Application No: 3449/21

Location: Dorset Street Upper, Dominick Street Upper and Saint Mary's Place North, Dublin 1

Proposal: Pursuant to the requirements of the above, notice is hereby given of:
A comprehensive phased redevelopment of the urban block bounded by Dorset Street, Upper Dominick Street and Saint Mary's Place, in Dublin 1, known as Dorset Street Saint Mary's Place Flats.

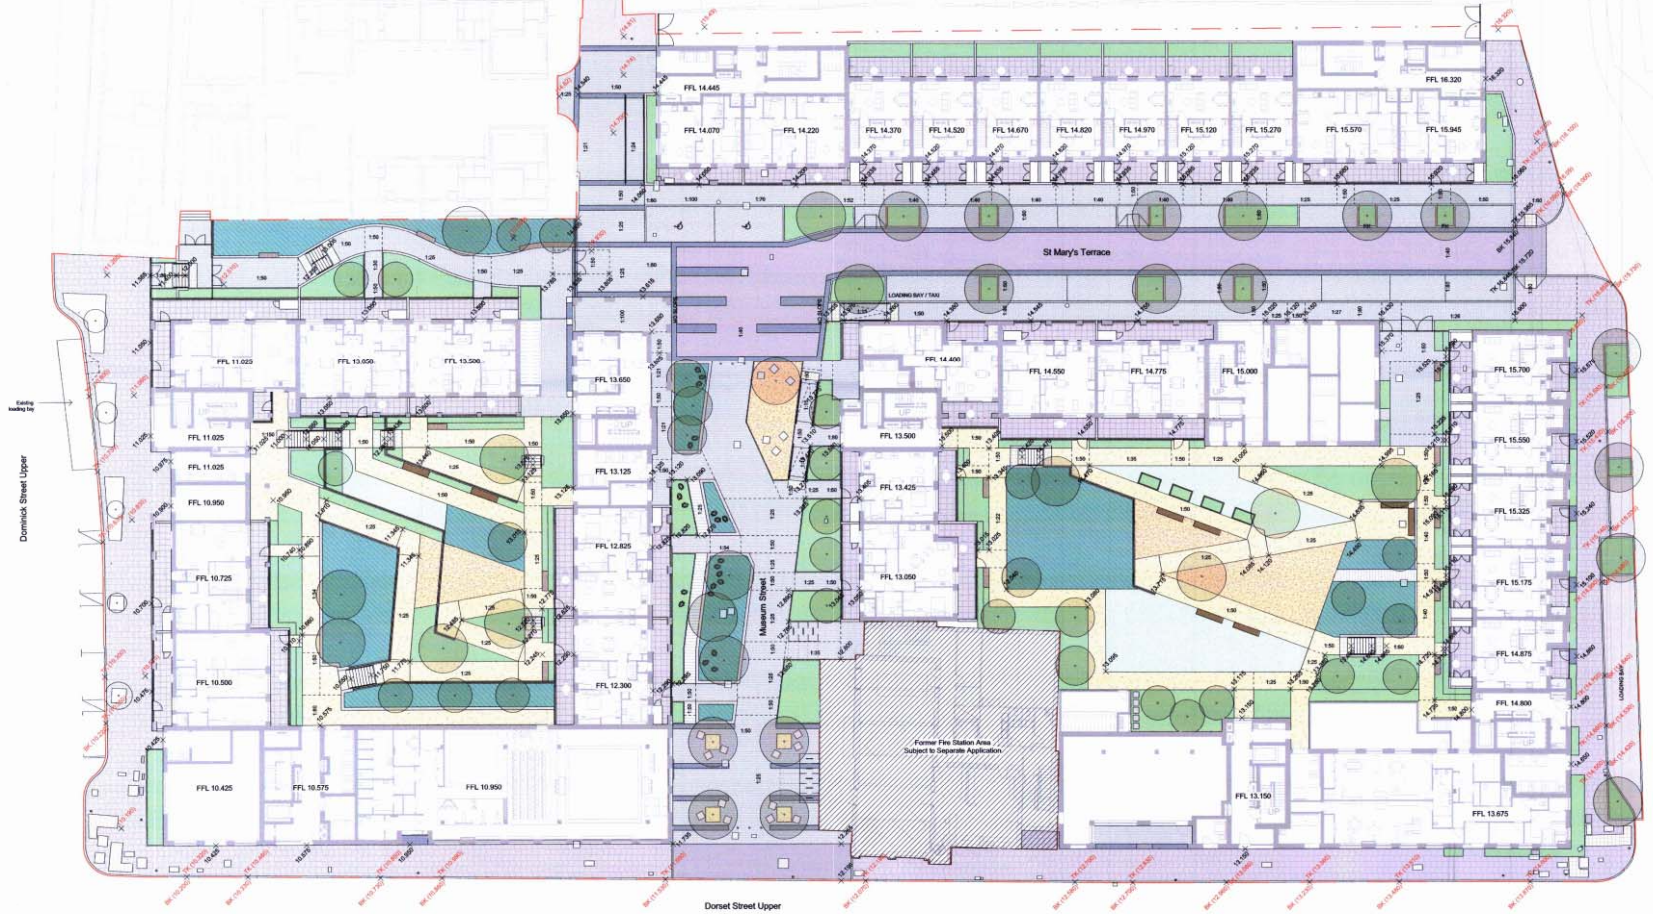
In the case of the distance between the Block A and the Mountjoy Street Houses to the west, the Part 8 application indicates a separation distance of approx. 23.7 metres however it would appear that the rear private open space to the houses within Block A accounts for only 5m of the overall 23m separation distance. In this instance, taking into account the relatively narrow nature of the rear private open space provision to the dwellings within Block A, there are some reservations regarding the potential for overlooking into the rear private gardens of the Mountjoy Street Houses to the west and the resultant impacts on existing residential amenity. This potential overlooking of the rear gardens could possibly be alleviated with a design alteration which would result in the 3 storey houses within Block A moving eastward, the green space to the front façade being replaced with a narrow green strip (defensible space) and either the removal of the proposed car parking along St Mary's Terrace or a narrowing of the road along St Mary's Terrace. These amendments would create a larger area of rear private open space for the houses within Block A and increase the separation distance between the opposing 1st floor windows of Block A and the Mountjoy Street Houses.

Following review of the layout, it is considered that the houses within Block A could be moved by a minimum of 1.6m away from the boundary to the rear lane at Mountjoy Street. It is further considered that Block A1 could be moved by a minimum of 1.4m away from the boundary to the rear lane at Mountjoy Street. The relocation of these sections of Block A will likely lessen any potential impacts on the existing houses to the west along St Marys Place and the rear

gardens of the Mountjoy Street Houses, whilst also allowing for the provision of larger areas of rear private open space (30sqm) to the houses within Block A.
